APPROVED MINUTES

September 20, 2012 Standards Committee Meeting

RE: Minutes from the September 20, 2012 Standards Committee Meeting

Figure 404-4D

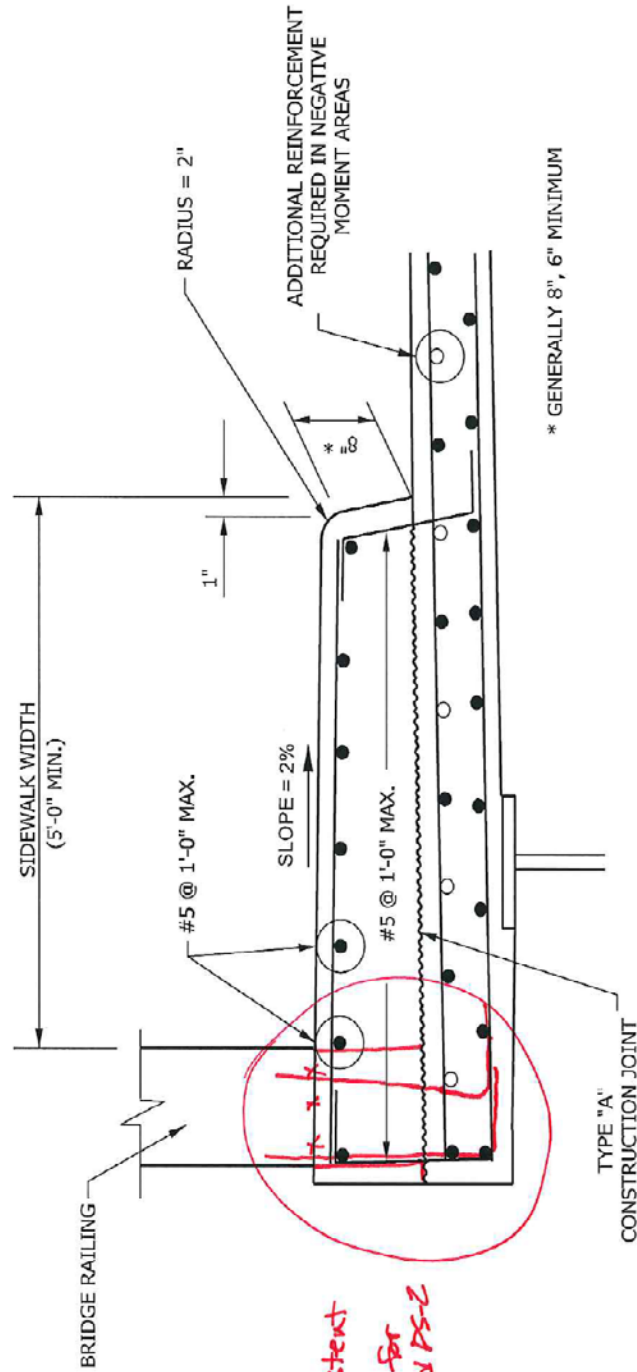
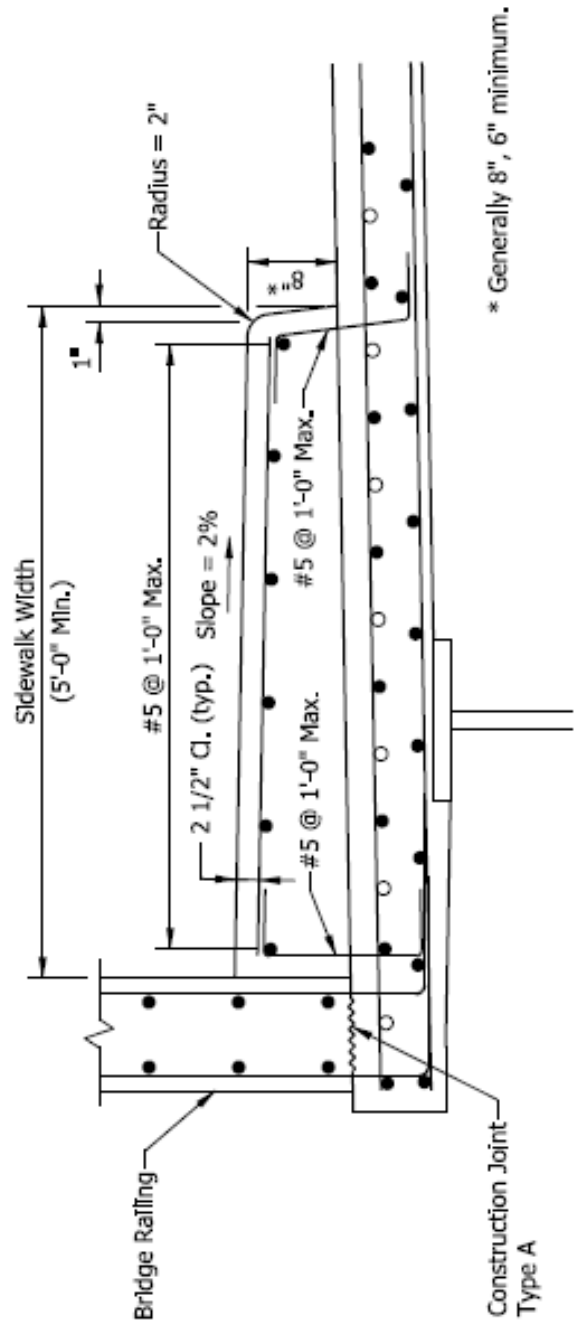
PROBLEM(S) ENCOUNTERED: With the publication of corrected Standard Drawings 706-BRPP-03 and -04, the bridge railing construction shown in Design Manual Figure 404-4D is no longer consistent with the Standard Drawings for pedestrian bridge rail in combination with a concrete sidewalk. The concrete bridge rail should not be shown sitting atop the sidewalk.

*Not consistent
with
std. Drwg. for
PS-1 and PS-2*

PROPOSED SOLUTION: Revise the Design Manual Figure 404-4D for consistency with the pedestrian bridge rail Standard Drawings 706-BRPP-03 and -04. See attached markup and final draft of proposed revised figure.

REVISED STANDARD DRAWING 802-SNGP-01 SIGN PLACEMENT (DRAFT)

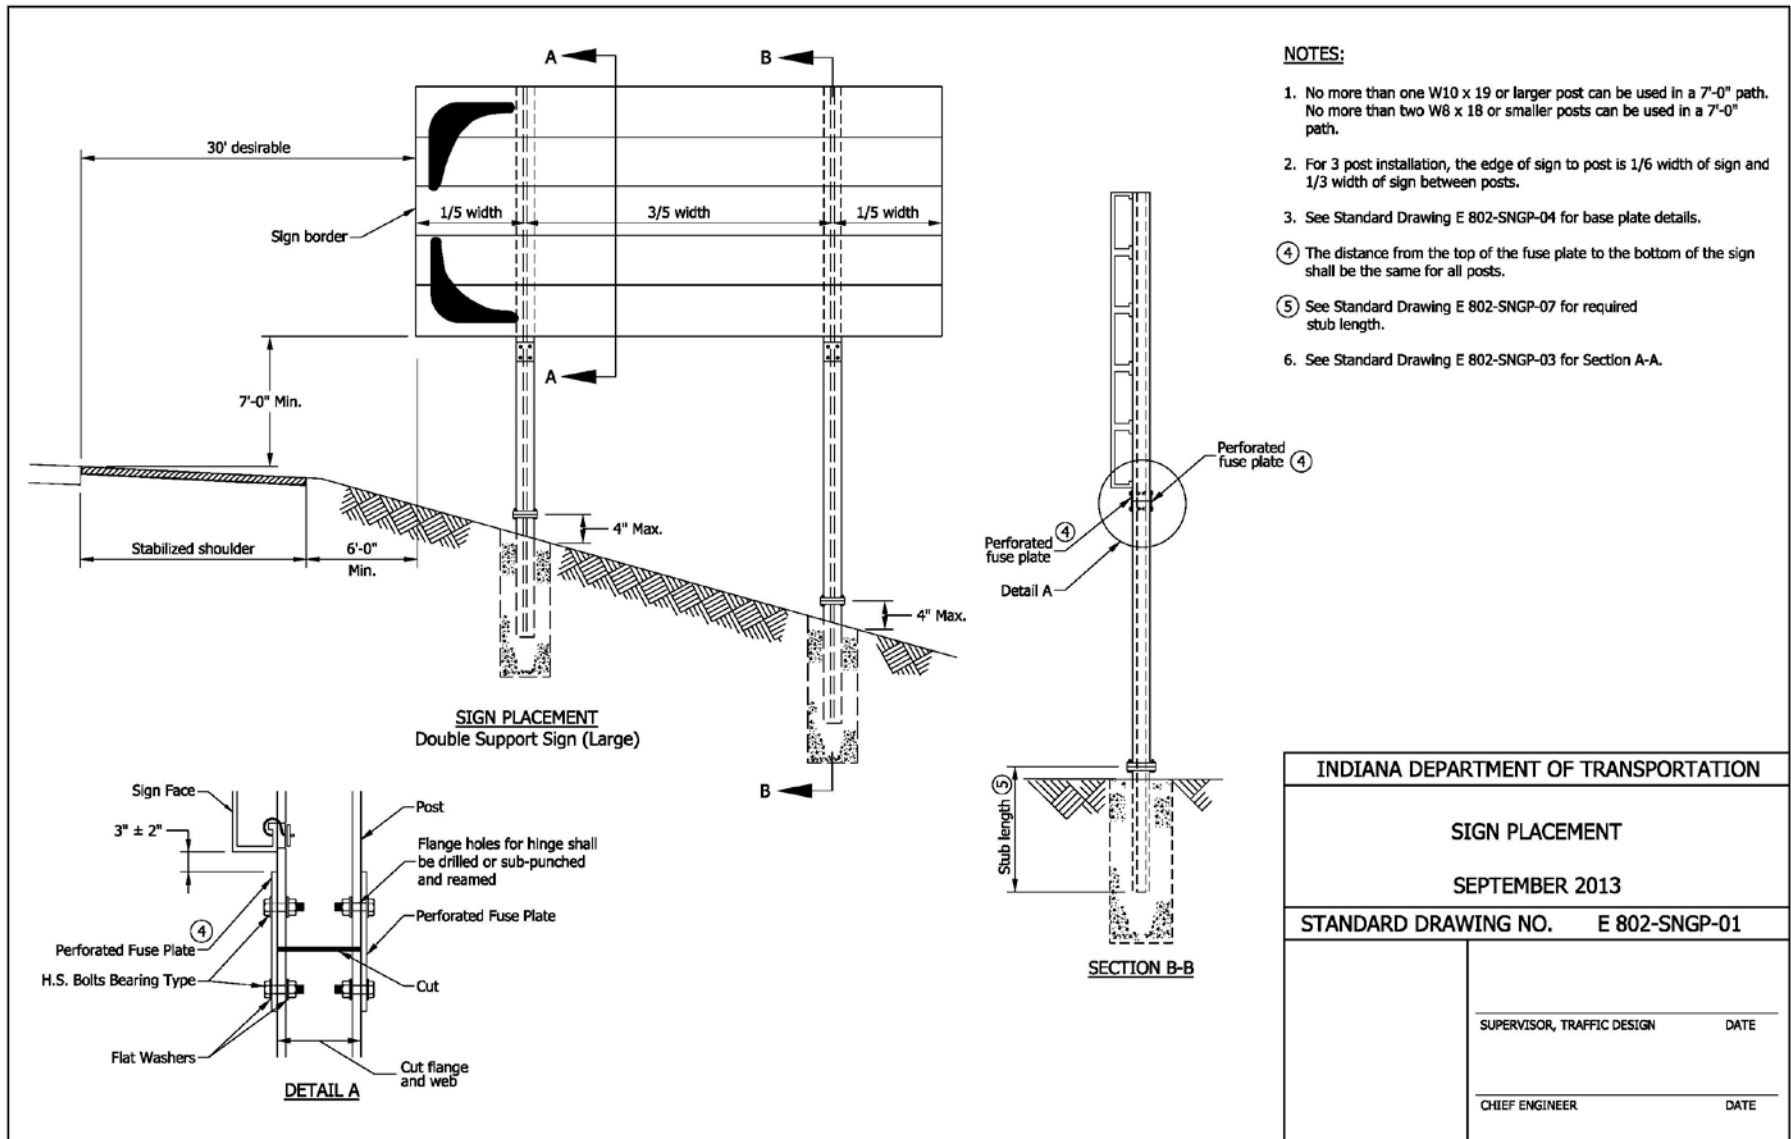
1. On panel sign assemblies the distance between the bottom of the panel sign and the top of the fuse plate often varies from one post to the other in the same assembly. This may lead to the breakaway mechanism not functioning correctly.
2. Clips that attach the sign panel to the support I-beams are not being installed on both sides of the I-beam for signs wider than 24' as they should be. This makes it more likely that the sign will separate from the supports.
3. Standard Drawing 805-SGSP-04 for signal strain poles contains incorrect dimensions for the base plate thickness and anchor bolt hole diameter.

DISCUSSION: Mr. Boruff presented this item as described on the proposal sheet. Mr. Garg stated that at the time of a hit, it would not behave the way it should, so the note was added for clarification.

1. Add a note to Standard drawing 802-SNGP-01 that "The distance from top of the fuse plate to the bottom of the sign shall be the same for all posts"
2. Revise Standard drawing 802-SNGP-03 to indicate that clips on both the left side and right side of the posts are required for signs wider than 24'.
3. Revise Standard drawing 805-SGSP-04 by correcting the anchor bolt hole diameter to 2 1/2" (currently shown as 2") and the base plate thickness to 2 1/2" (also currently shown as 2").

EXISTING STANDARD DRAWING 802-SNGP-03 SIGN PANEL DETAILS (WITH MARKUPS)

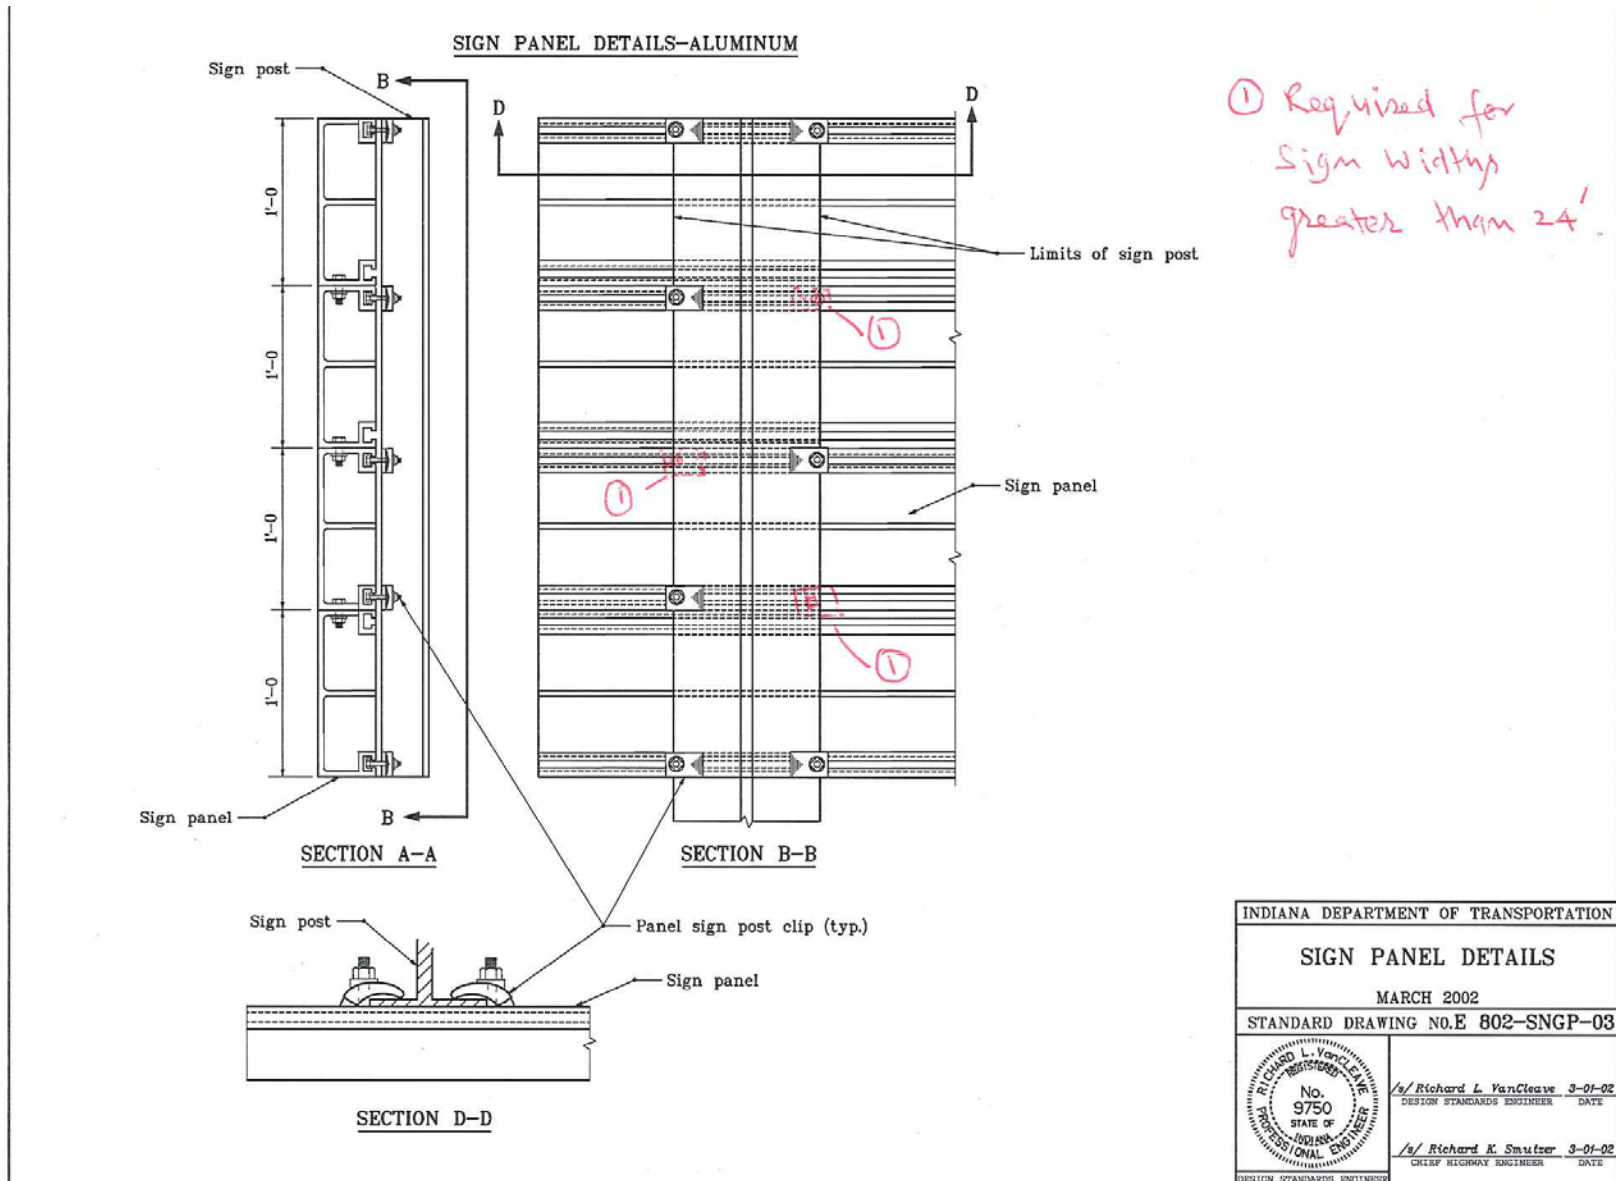
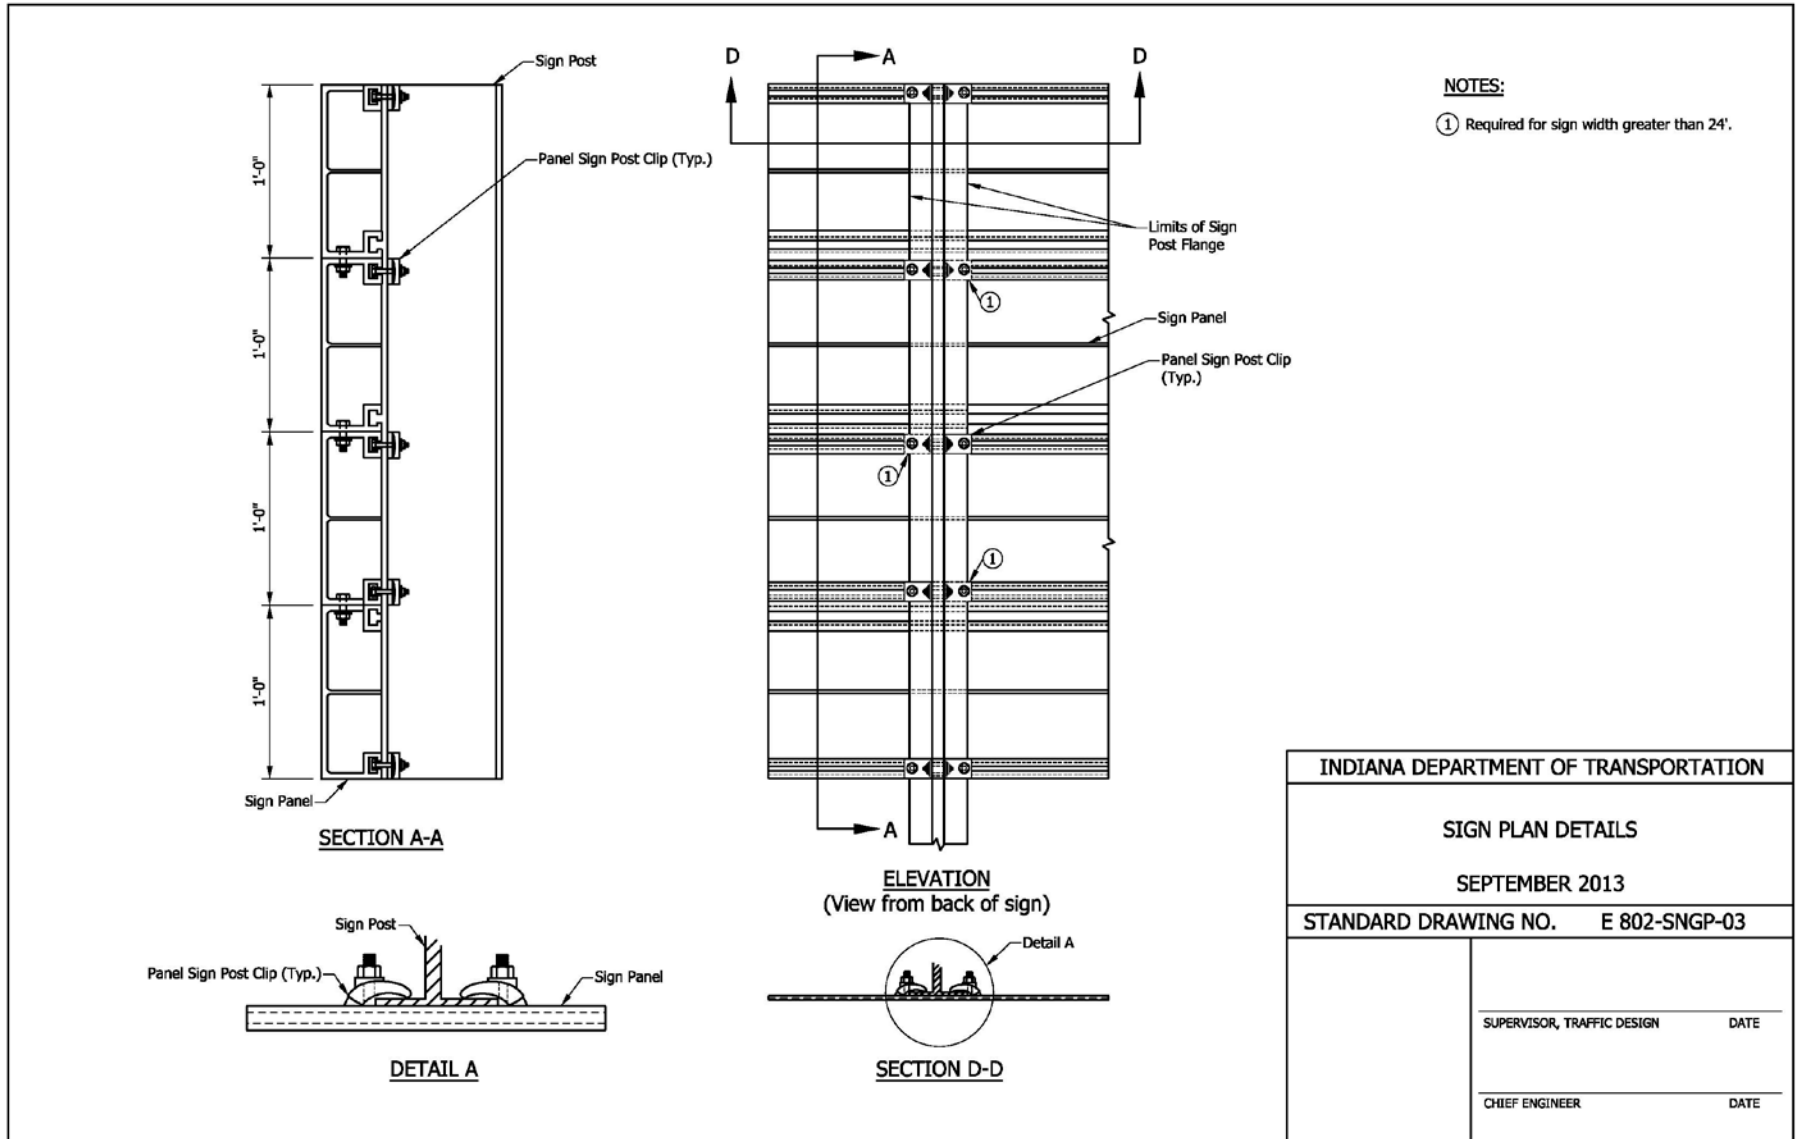
Mr. Boruff continued his explanation of the drawing revisions in regards to clips. Mr. Pankow inquired about the size of the signs and how this applies. Mr. Miller expressed concerns about signs that have blown down following heavy storms. Mr. Garg said that is due to the design of the fuse plate, and they are looking into revising that plate, due to the fatigue on that fuse plate.
